7ABC BAYHAM STREET CAMDEN LIFESTYLE

SECTION 73 PROPOSED SCHEME AMENDMENTS
PLANNING APPLICATION
NOVEMBER 2020

This document has been prepared to present the amendments to the consented scheme (Ref: 2018/3647/P) which are predominantly internal and designed to suit the hotel brand.

GROUND FLOOR PROPOSED

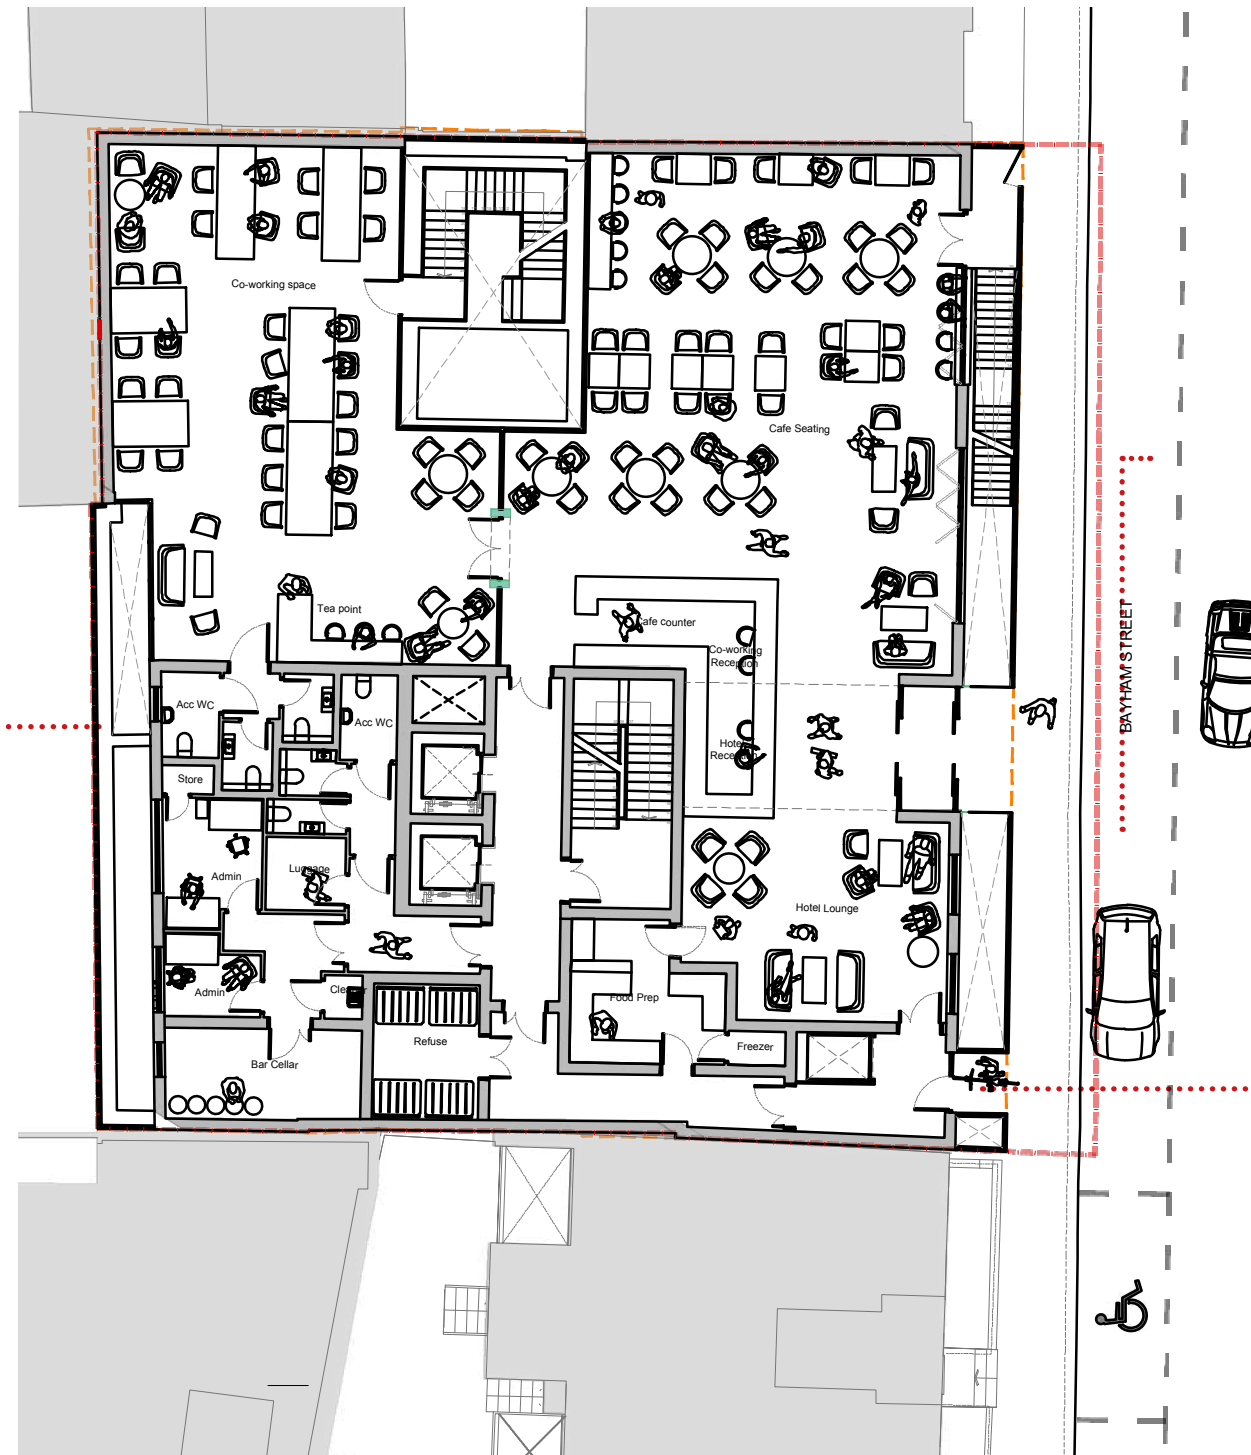
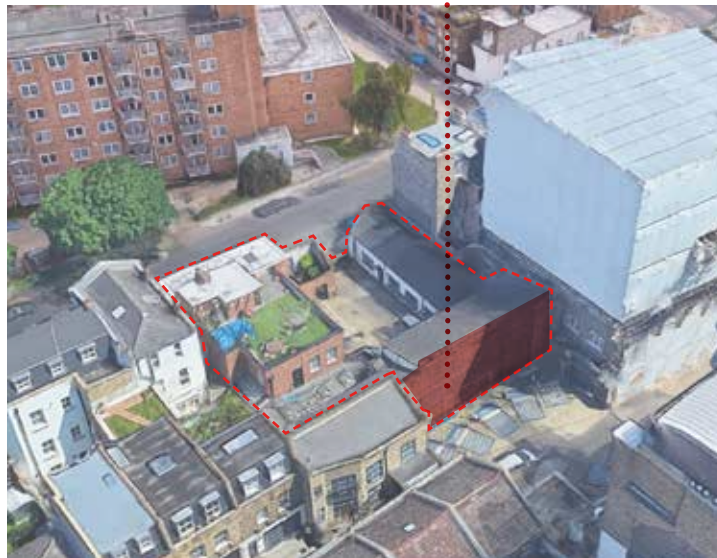
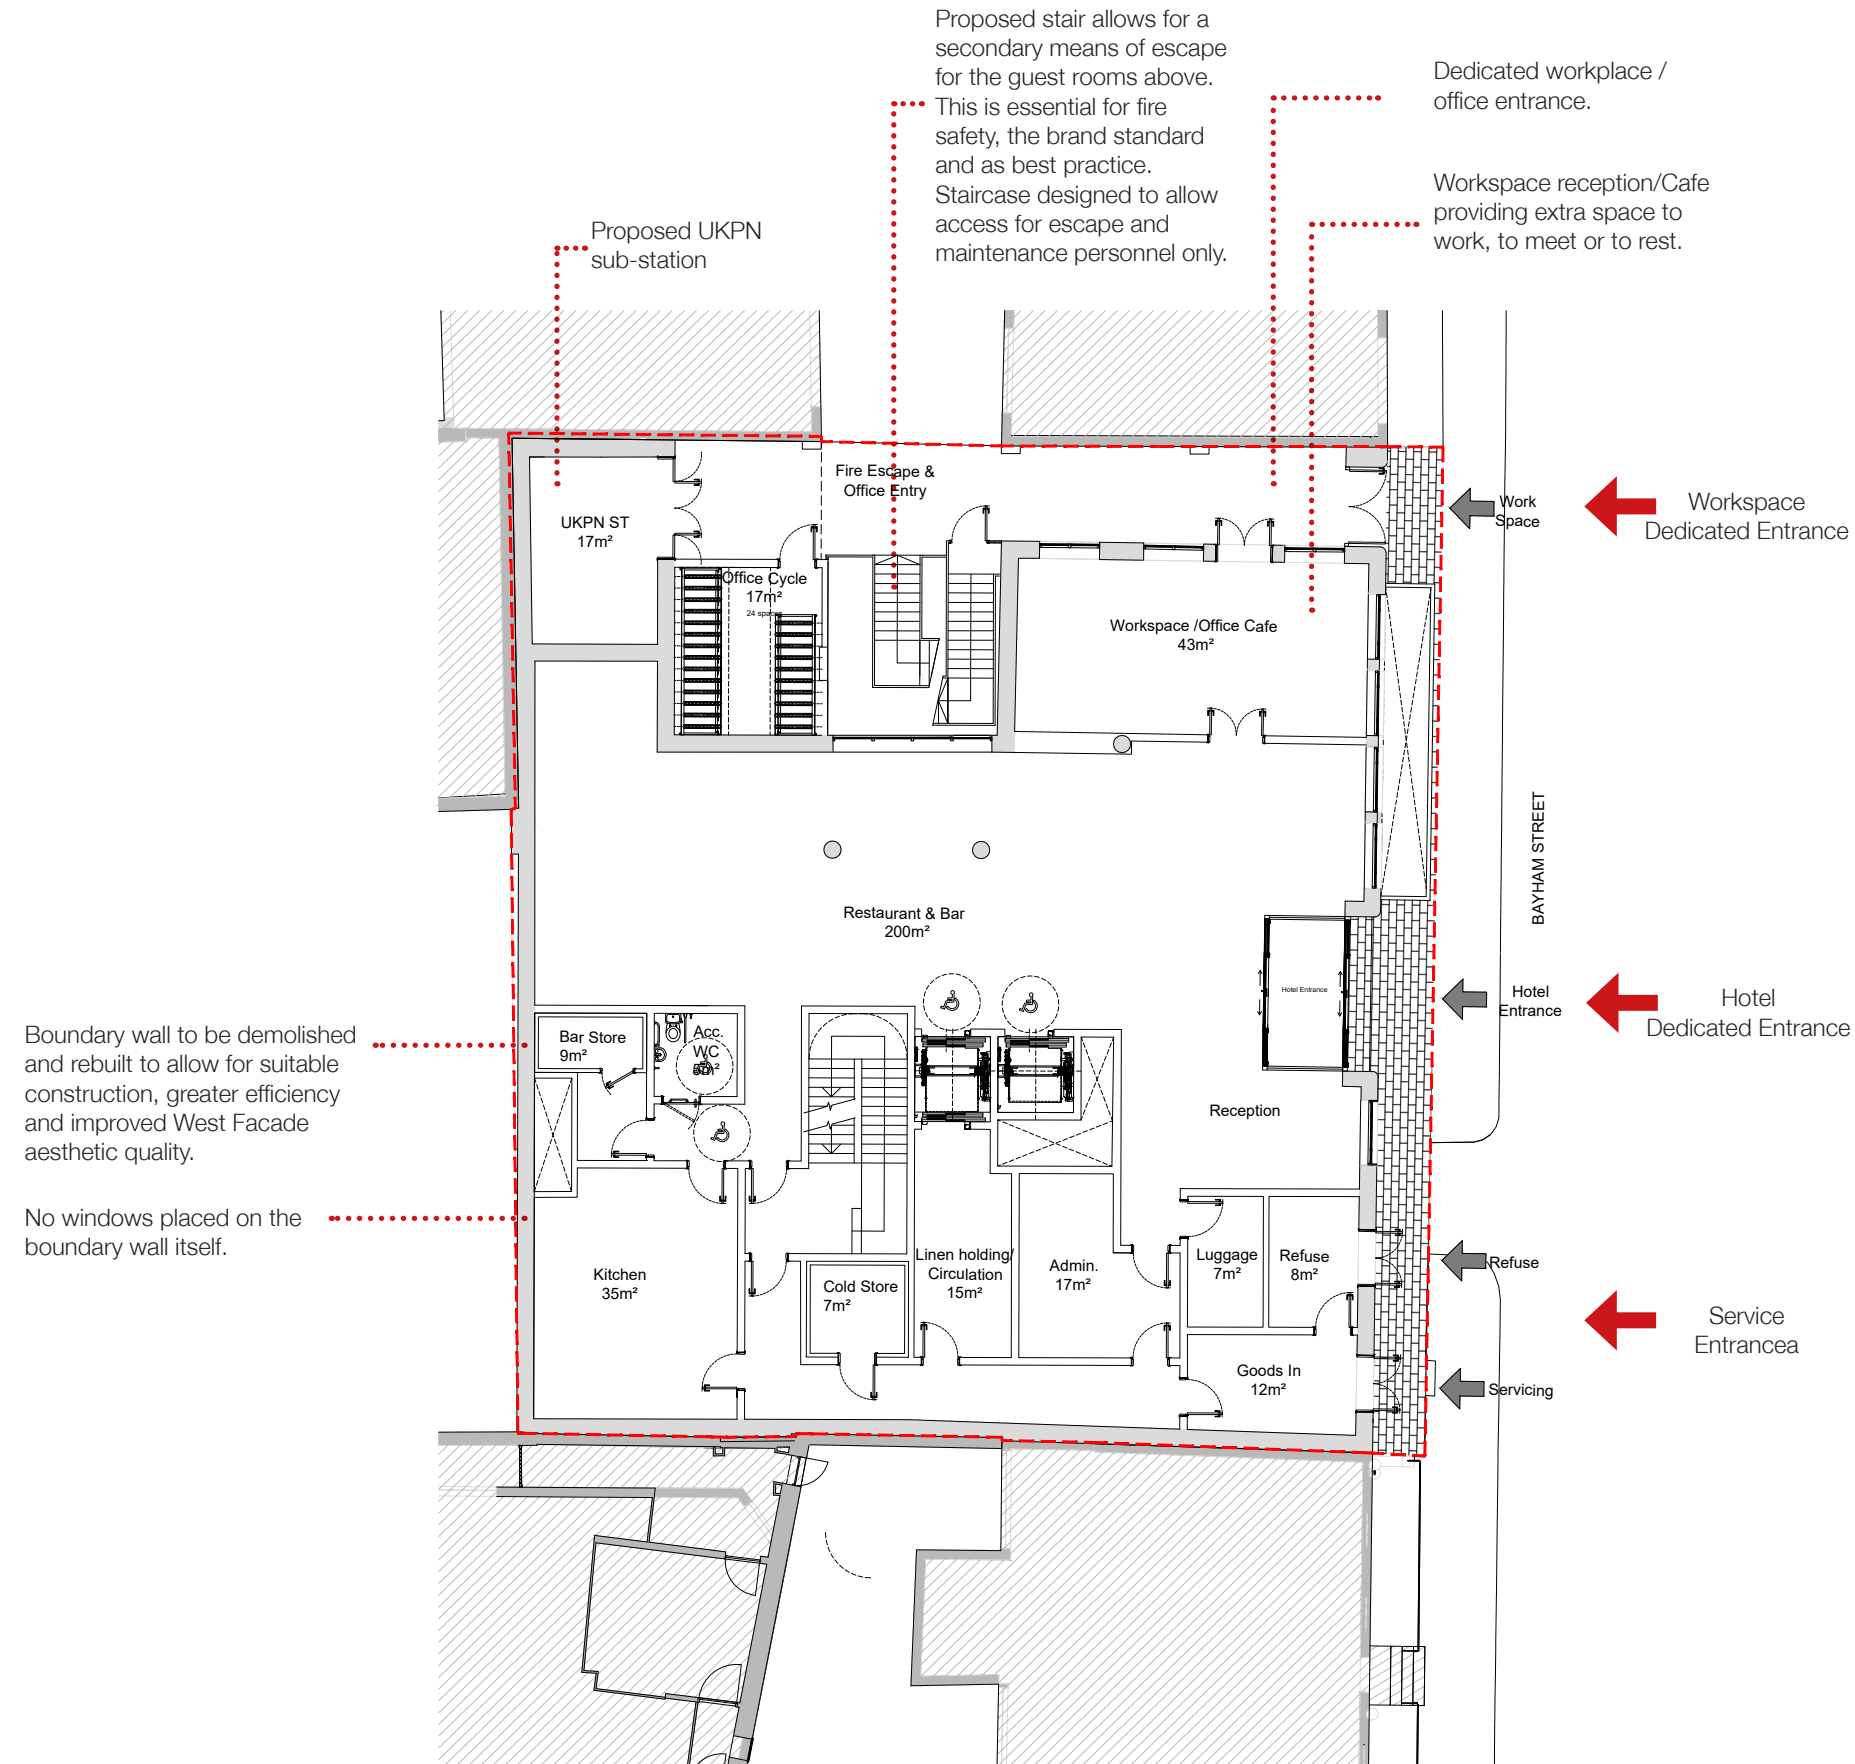
The consented scheme is lacking UKPN sub station provision and areas for service and MEP provision. No service risers indicated.

Retained boundary wall from elevations not shown within consented scheme. Lightwell too narrow for suggested use.

Service entrance and BOH areas have long circulation and inefficient layout.

- The ground floor has been revised to provide a more efficient fluid transition of spaces through improved permeability with independent entrances for hotel and office use. This is achieved through dedicated lower ground office space and the reduction of office space at ground floor.

- Ground floor level now hosts a dedicated work zone alongside a separate hotel cafe, bar and restaurant area.
- Updated main entry to accommodate accessible entry and draft protection

- Revised lift access to better address public spaces.
- Dedicated office entry to the north of the site, which in addition acts as the secondary emergency escape route and access route for office cycles and substation maintenance.

- Cycle storage – 24 spaces (increase of 2 from existing approved scheme).
- BOH offer revised to improve hotel functionality.
- The consented scheme had no allowance for incoming electrical utility infrastructure. The proposed scheme includes the provision for a dedicated DNO substation within the building footprint.

FIRST FLOOR

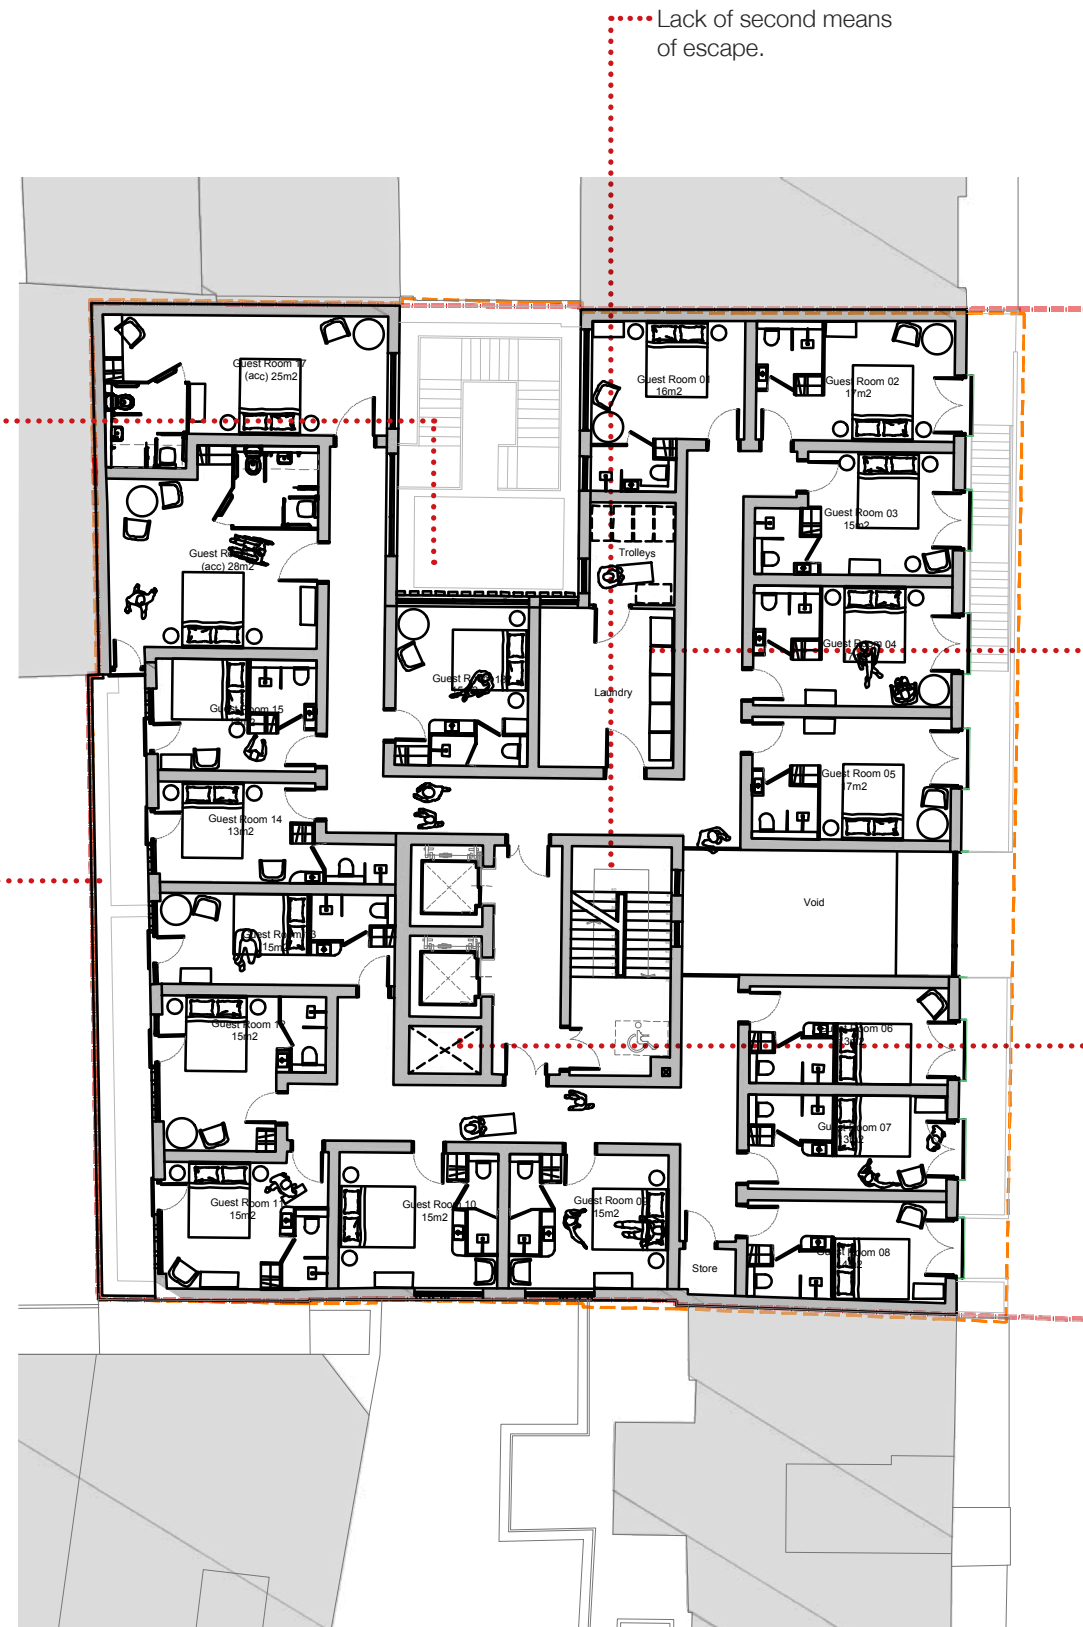
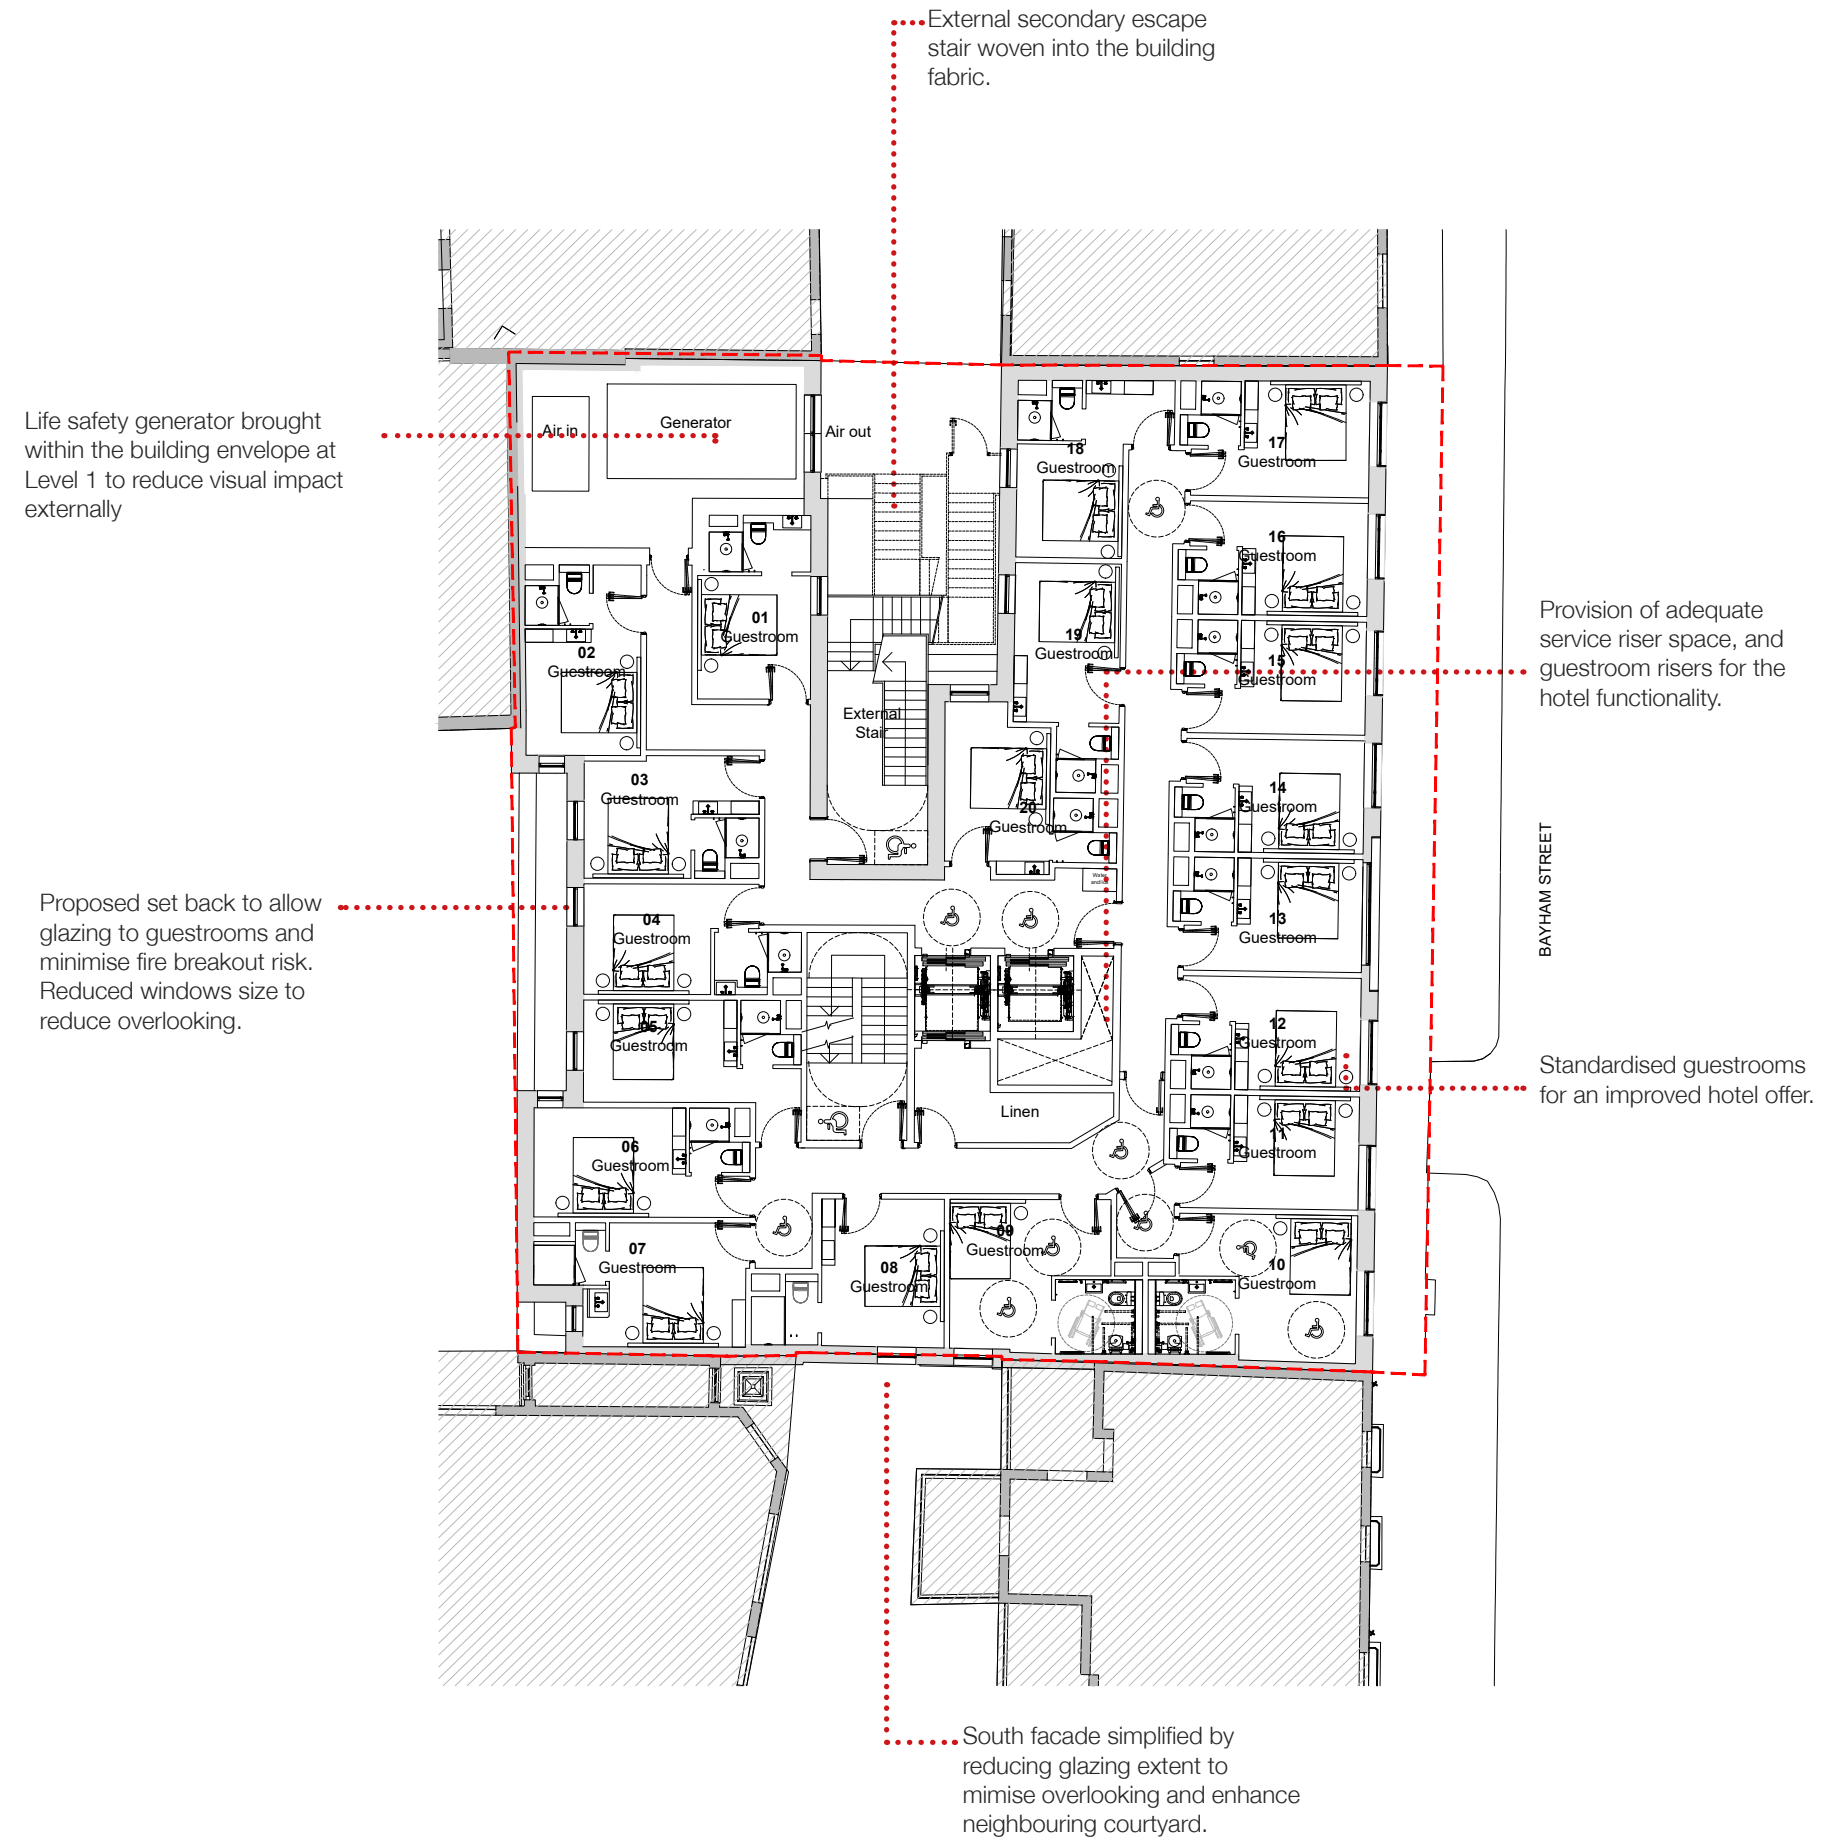
Excessive glazing into courtyard,
impacting on overlooking issues
and maintenance.

Retained wall compromises 2.5
levels of guestroom outlook.
Lightwell is too narrow for
intended use and creates a
maintenance issue.

Lack of second means
of escape.

Hotel Servicing not
centralised.

Lack of services riser space
in core and also within
guestroom spaces.

- Guestroom configurations revised to improve the general circulation with the scheme.
- Guestroom layouts standardised to align with brand requirements.
- Linen stores introduced to each level with direct lift access.
- Risers allowed for to comply with MEP requirements.
- Life safety generator brought within the building envelope at Level 1 to reduce visual impact externally

There are various critical Life safety systems required to comply with the fire strategy for the hotel. The fire strategy details the requirement for a water suppression system along with smoke extract, which also supports longer escape routes. These systems will be connected to the primary incoming electrical power, but they must be guaranteed to function in an emergency. Accordingly, a secondary electrical supply is required. A suitable secondary grid connection is not available, therefore to satisfy this requirement it is proposed to provide a life safety generator unit, compliant with BS9999.

The life safety generator will provide a backup electrical supply to a life safety switchboard located in a 2hr fire rated switch room adjacent to the generator enclosure. The generator will only operate for periodic maintenance/testing and in emergency conditions (in the event of the loss of principal power connections).
